L-PI-05-071 TS 5.6.5.d

Prairie Island Nuclear Generating Plant Unit 1 Docket 50-282 License No. DPR-42

#### Core Operating Limits Report (COLR) for Prairie Island Unit 1 Cycle 23, Revision 1

# PRAIRIE ISLAND NUCLEAR GENERATING PLANT CORE OPERATING LIMITS REPORT UNIT 1 – CYCLE 23 REVISION 1

Figure 3
Rod Insertion Limit, 128 Step Tip-to-Tip, One Bottomed Rod
(Technical Specification 3.1.4 Condition B)

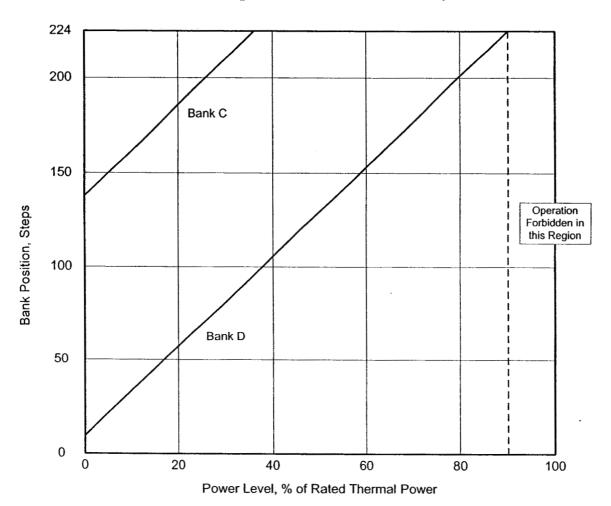
- Revised Isothermal Temperature Coefficient (ITC) upper limit from <0 pcm/°F for power levels >70% Rated Thermal Power (RTP) to less than a line that slopes linearly from 0 pcm/°F at 70% RTP to -2.9 pcm/°F at 100% RTP.
- Revised the title of Figure 3 to reference Technical Specification 3.1.4 Condition B.
- Revised the title of Figure 4 to reference Technical Specification 3.1.4 Condition A.
- Added references 24 and 25 to include the 50.59 screenings written to issue Revision 1.
